NORTHAMPTON
GATEWAY
STRATEGIC RAIL FREIGHT INTERCHANGE

STATEMENT OF COMMON GROUND BETWEEN THE APPLICANT AND RAIL CENTRAL

DOCUMENT 7.17

STATEMENT OF COMMON GROUND BETWEEN
THE APPLICANT AND RAIL CENTRAL | 30 NOVEMBER 2018

RAIL INTERCHANGE
ILLUSTRATIVE GENERAL
ARRANGEMENT
KEY PLAN

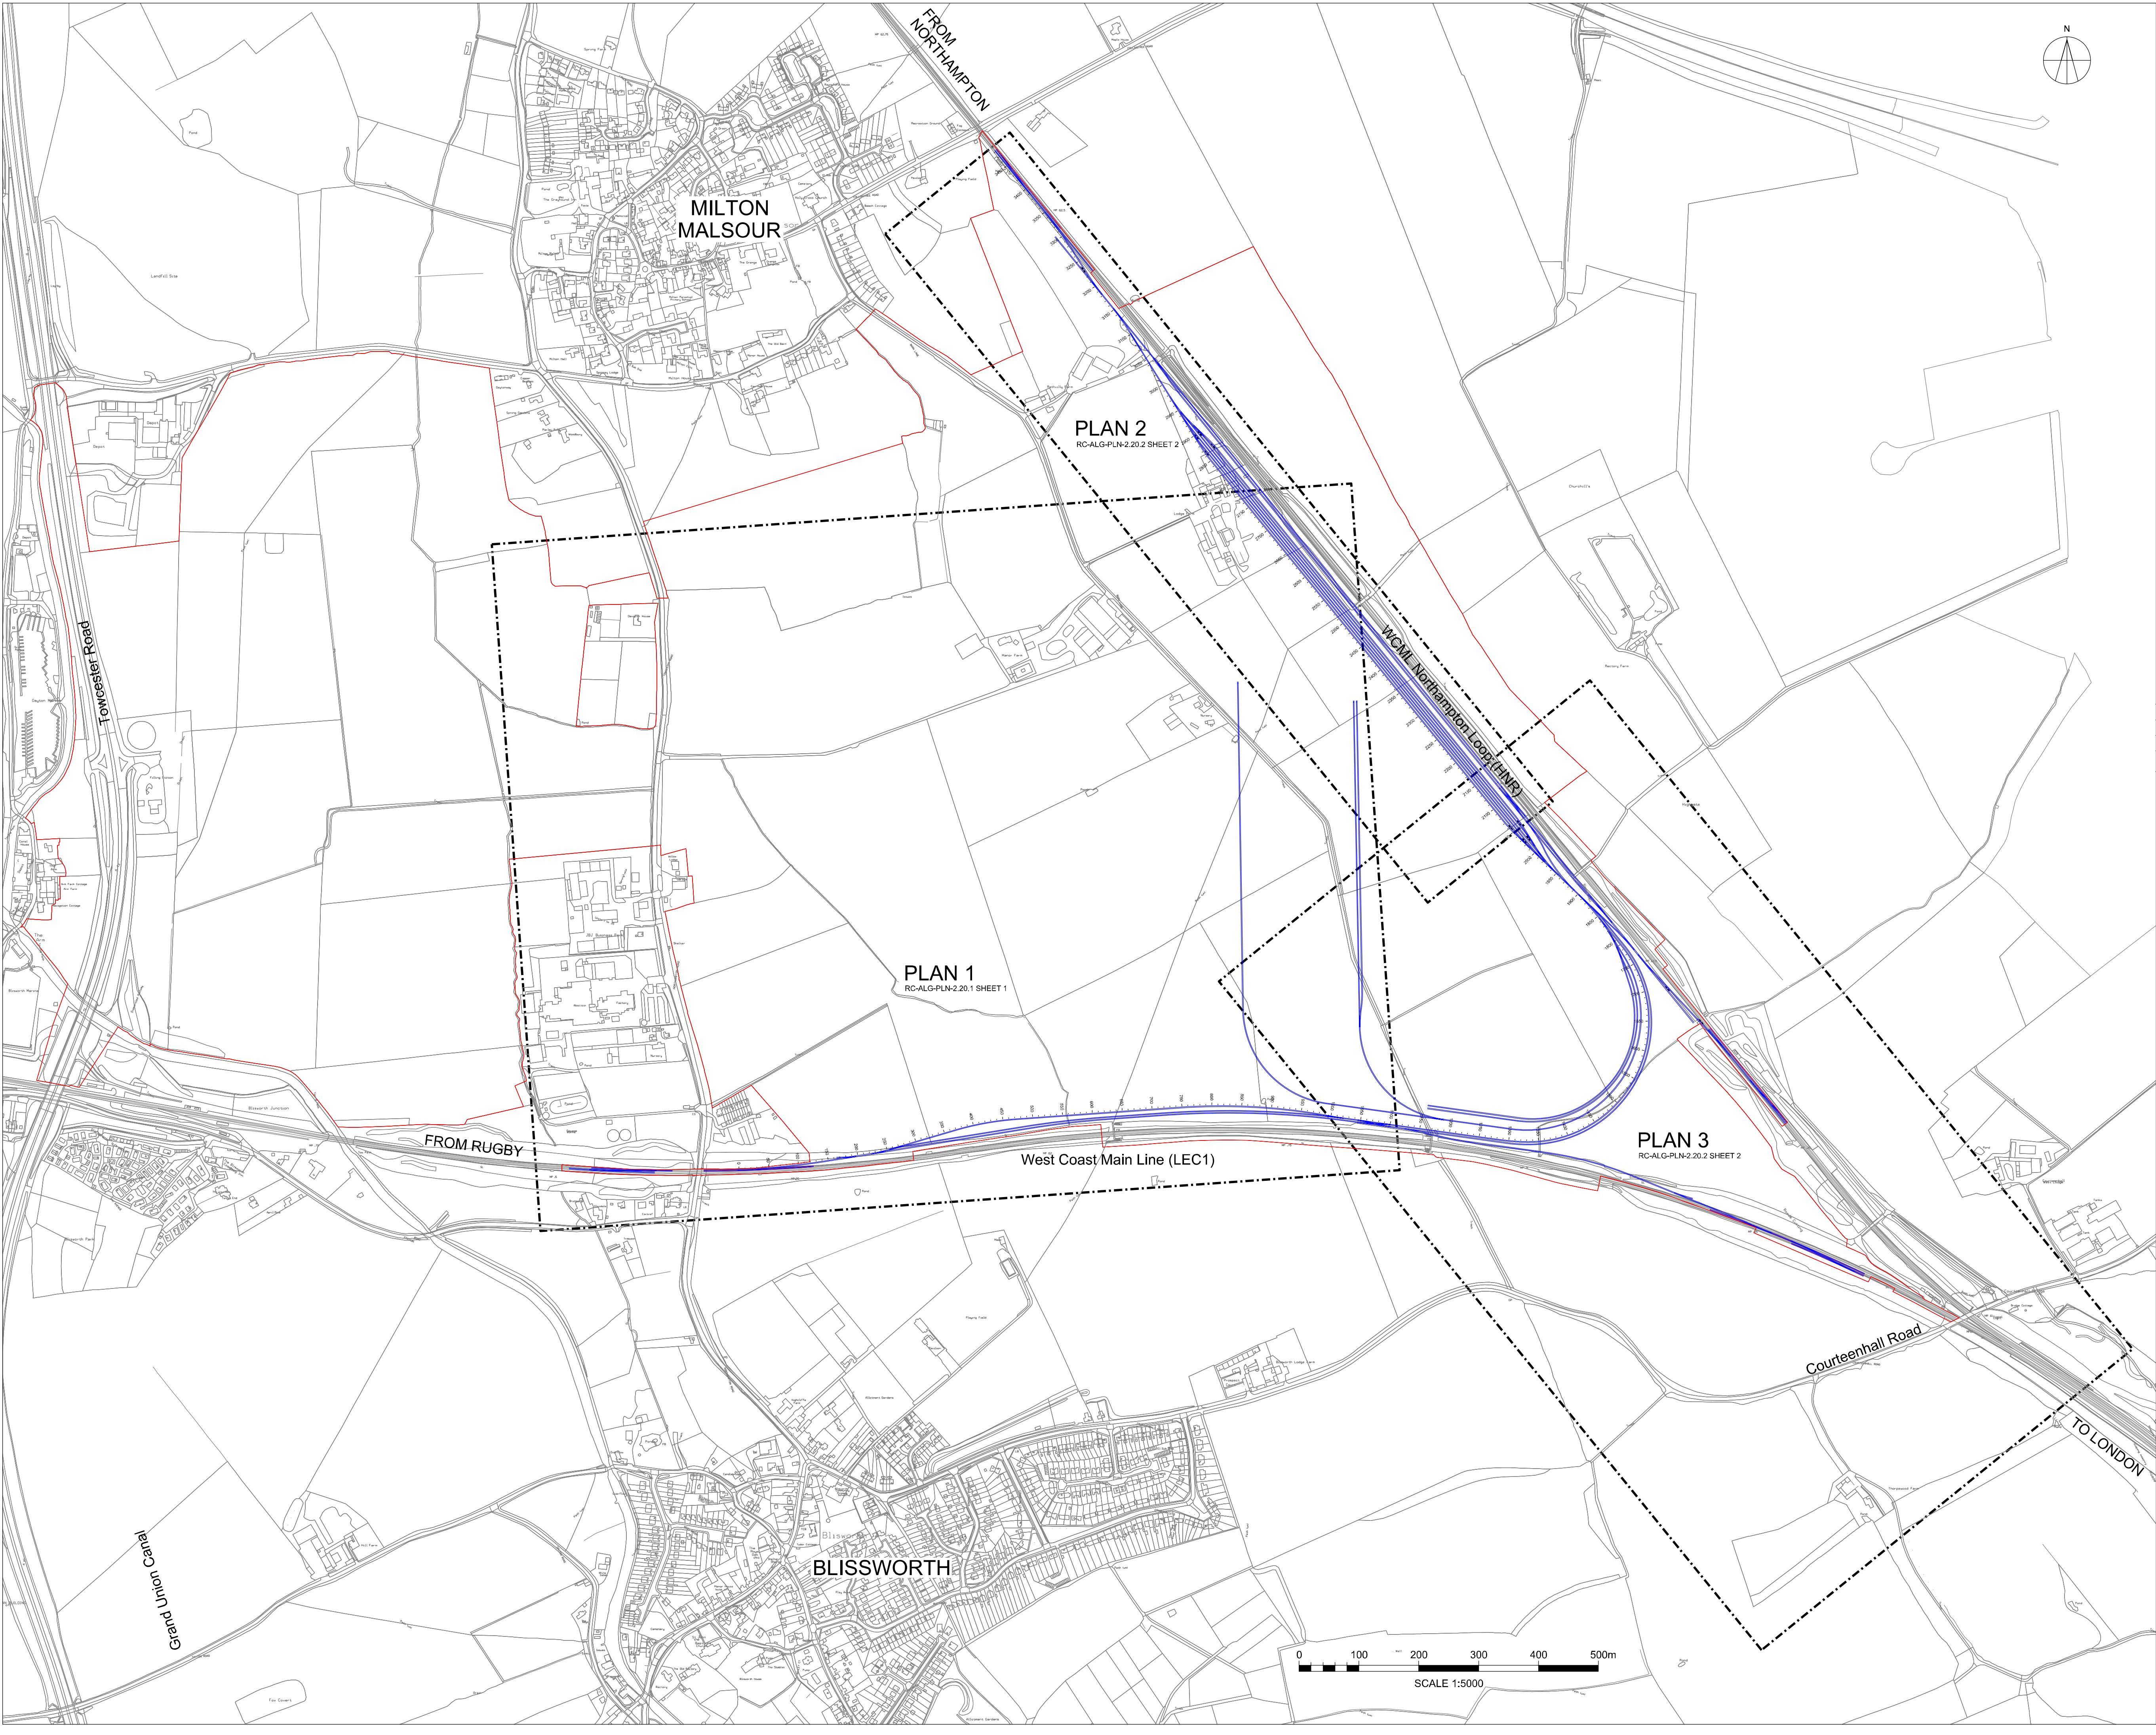
10. In the Interrelationship Document, paragraphs 4.1 to 4.9, Rail Central provide their views on compatibility of the two schemes. Roxhill, based on an initial view of the application documentation just submitted, do not agree that the two schemes as shown on the application plans are compatible.

11. Rail Central have stated in paragraph 3.2.1 of the Interrelationship Report that "Both Projects will be constructing new railway lines at the NLL to connect to their respective intermodal facilities. Configuration of connection points will be determined at detailed design stage in order to facilitate both connections".

12. However, the physical layouts of the network connections shown on the respective rail plans submitted are incompatible with the positioning of the southern connections being in the same location. This is not a conflict which can be left to the detailed stage because the repositioning of the south connections for either scheme would result in the lengthening of the junction which may take a scheme beyond Order limits and have implications on capacity and pathing. This is because entry and exit times will be extended and the amount of wrong direction running will be increased, thereby blocking both the Up and Down Northampton Lines for longer.

13. None of the schemes referred to in paragraph 4.2 of the Interrelationship Report are comparable situations.

14. Recent technical assessment of the respective main line connections onto the NLL (slow lines) indicates that an appropriate design solution can allow both sets of main line connections to be achieved within their respective order limits, without requiring any changes to the main line entry/exit speeds and adding less than 5 seconds of additional "wrong line" working for trains to and from the main line. It is considered that with detailed design the level of wrong line working could be further reduced. A common approach to signalling would allow both schemes to have the opportunity of higher speed entry and exit onto the main lines. Further

information on track and signalling design will be provided following review with Network Rail.

JUNCTION 15A
GENERAL ARRANGEMENT

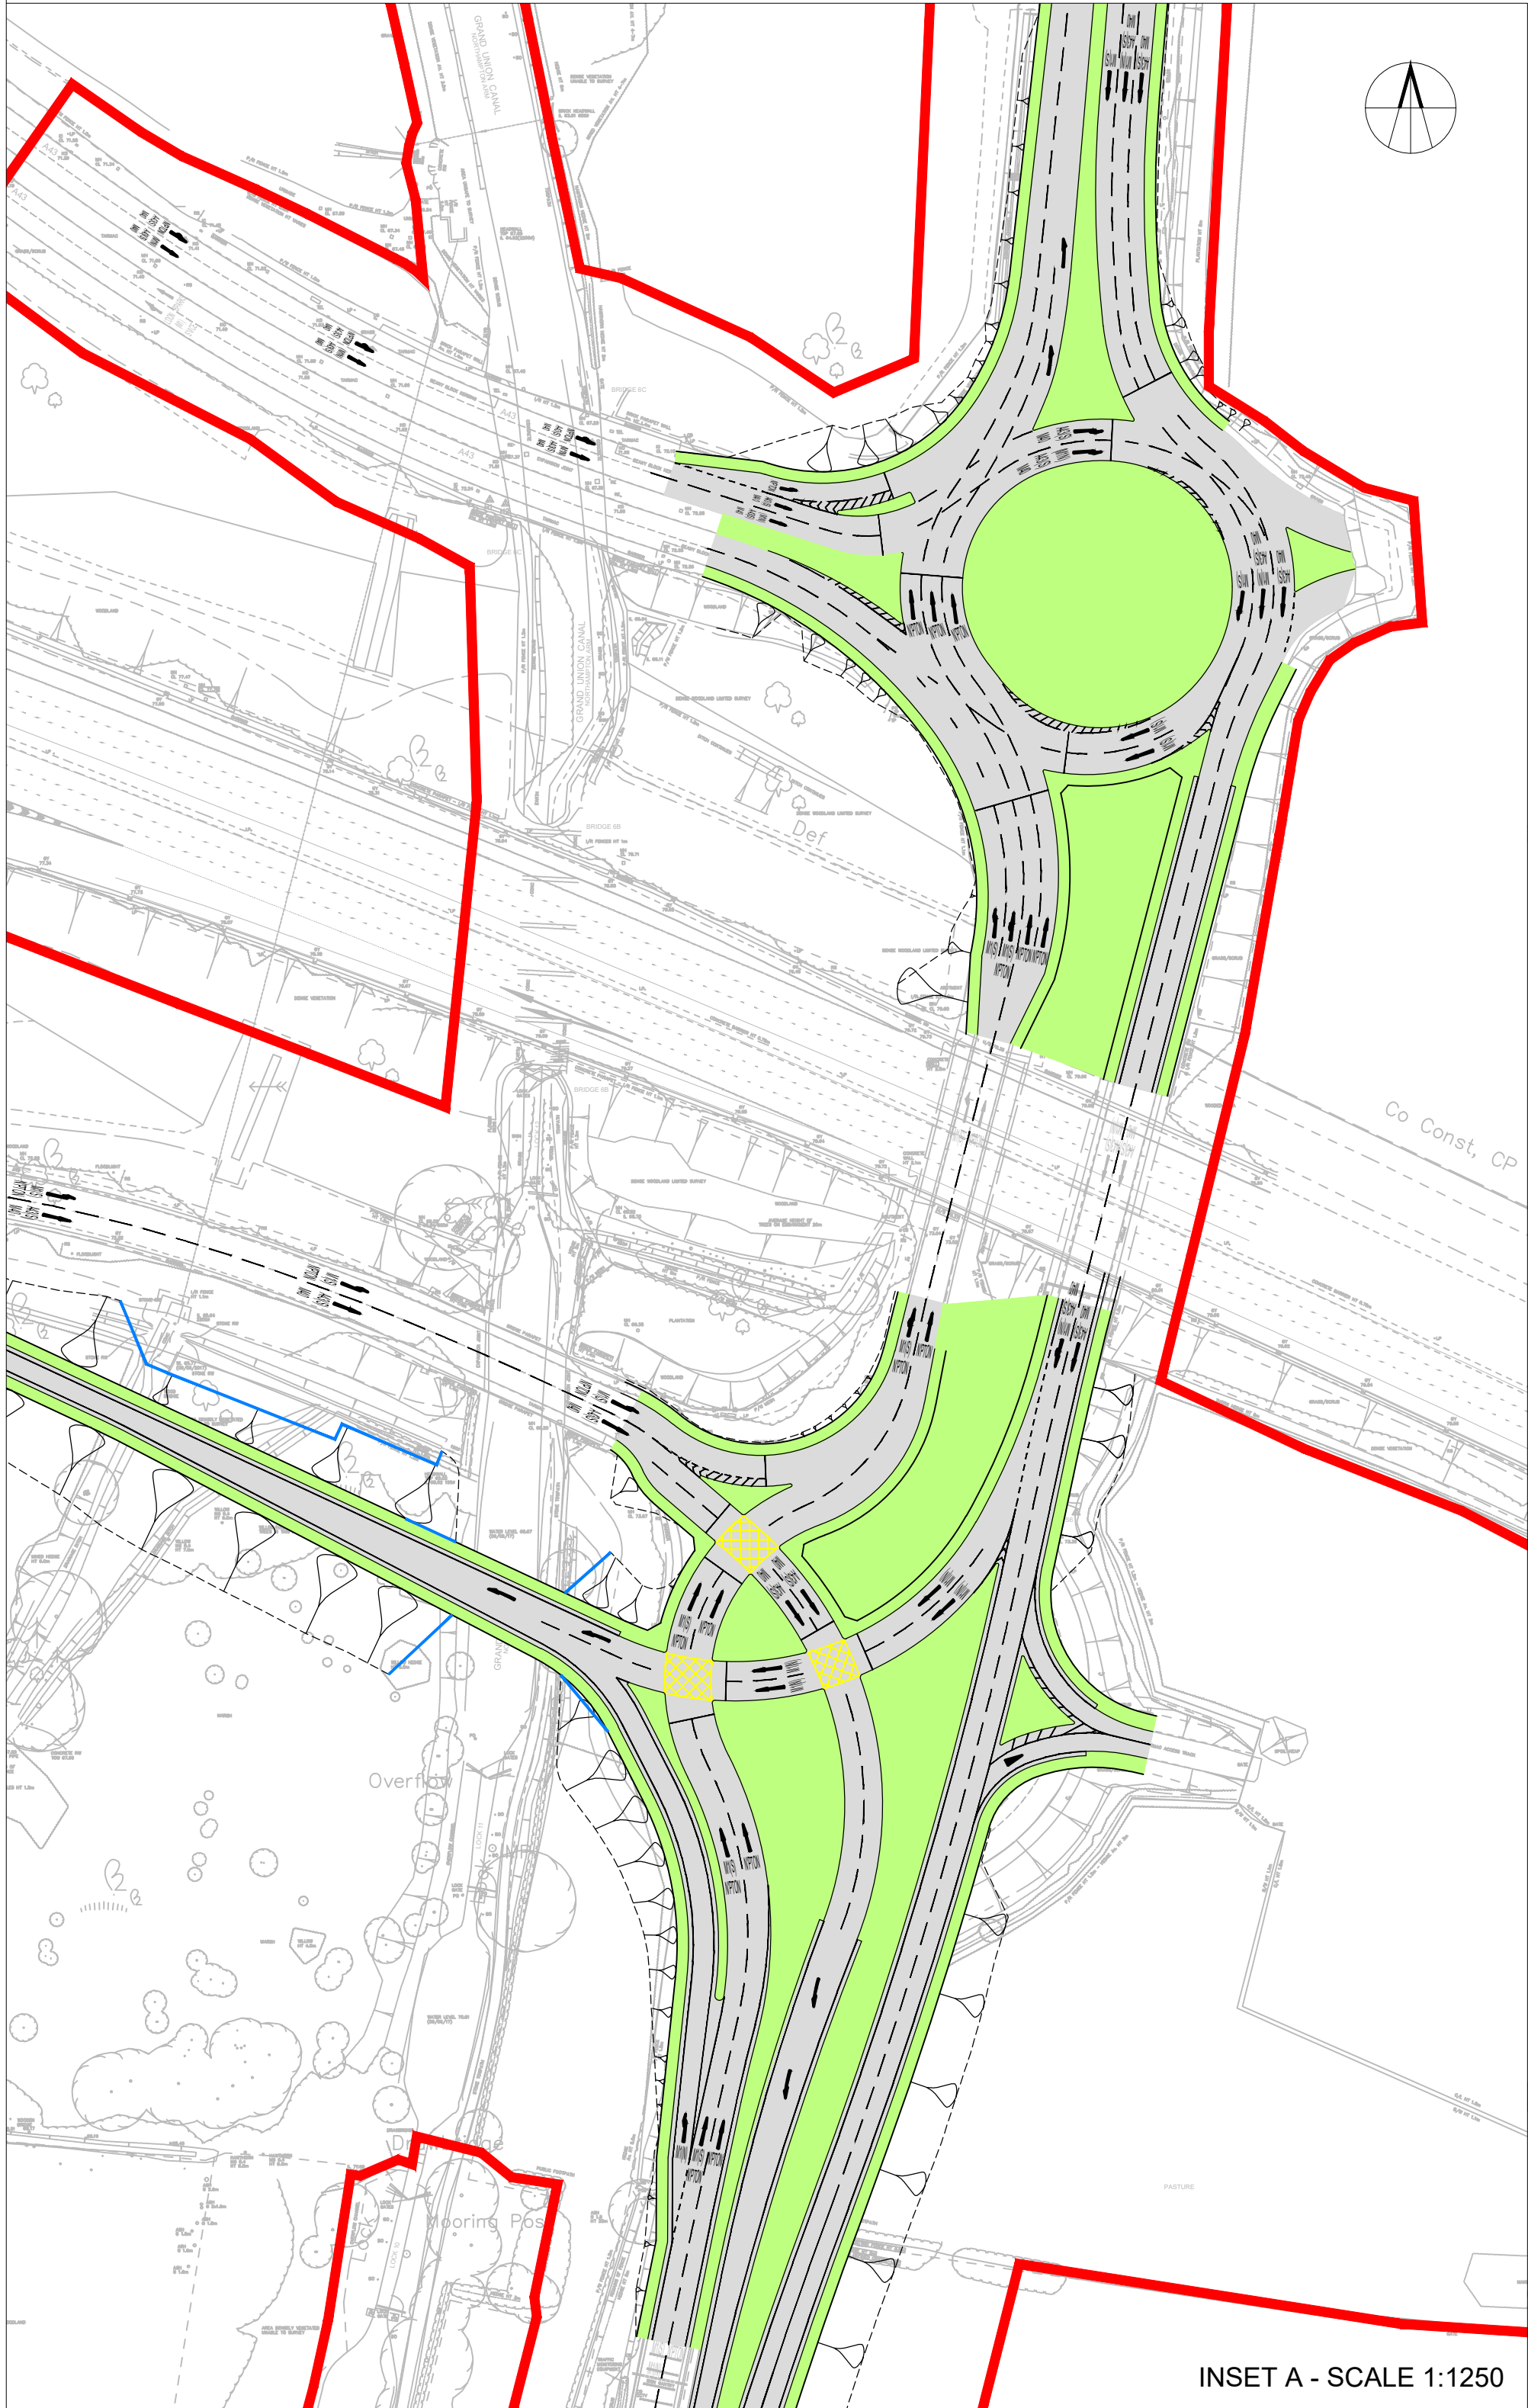
23. Paragraph 4.25 of the Interrelationship Report indicates that the Northampton Gateway draft DCO could be amended to "facilitate the option that [the Northampton Gateway Junction 15a works] may not be required in the event that the Rail Central Junction 15a works are undertaken". Roxhill agree that it would be appropriate to amend the Roxhill dDCO to ensure that the obligation on Roxhill to carry out the Northampton Gateway Junction 15a works no longer applies if the Rail Central Junction 15a works are undertaken, but only if the Rail Central Junction 15a works are sufficient to mitigate the impact of both schemes.

24. The works proposed by Rail Central to J15A in their application are different than those initially proposed by Rail Central upon which the work which informed the Northampton Gateway CIA was prepared. At the time of the preparation of the Northampton Gateway CIA Rail Central were proposing more extensive enhancements to J15a. This was prior to a subsequently smaller scheme being put forward by Rail Central with its Stage 2 Consultation. The more extensive scheme was modelled and the outcome included in the CIA. The Stage 2 consultation scheme came too late to be modelled and any outcome included within Northampton Gateway's CIA, however the amended mitigation proposals were referred to.

25. Roxhill is in the process of examining the Rail Central application and is not in a position to conclude that such the approach outlined in paragraph 23 above is appropriate until it has had the opportunity to understand fully the effect of the revised Rail Central highway mitigation strategy. The review of the recent application, carried out to date, suggests that the works now proposed at Junction 15A may not be sufficient to accommodate the traffic impact of the Rail Central proposals alone and therefore not sufficient to accommodate the cumulative impact, however this will be kept under review if further information is forthcoming from Rail Central in time to have regard to it in the CIA, which is to be delivered for Deadline 4. Roxhill will attend a meeting to discuss such information if it is forthcoming and if it will facilitate the provision of a best informed CIA by Deadline 4.

26. The modelling work undertaken as part of the junction design for Rail Central indicates that Rail Central's proposed design for Junction 15a increases capacity sufficiently to deal with increased traffic flow that results from the Rail Central development coming forward on its own, or from the cumulative traffic loading from both Rail Central and Northampton Gateway should they both be granted consent. Rail Central has proposed a technical meeting between experts to further address the points made by Northampton Gateway within paragraphs 23 and 25 above.

27. Rail Central has also set out in the Interrelationship Report phasing scenarios to cover the events where either Rail Central or Northampton Gateway commence development of the Junction 15a works first or whether Northampton Gateway commence these works significantly in advance of Rail Central (paragraphs 4.24.1 - 4.24.3 of the Interrelationship Report). Protective Provisions to manage this can be contained for Highway England's benefit in the Northampton Gateway DCO alongside those sought within the Protective Provisions for the benefit of Rail Central.
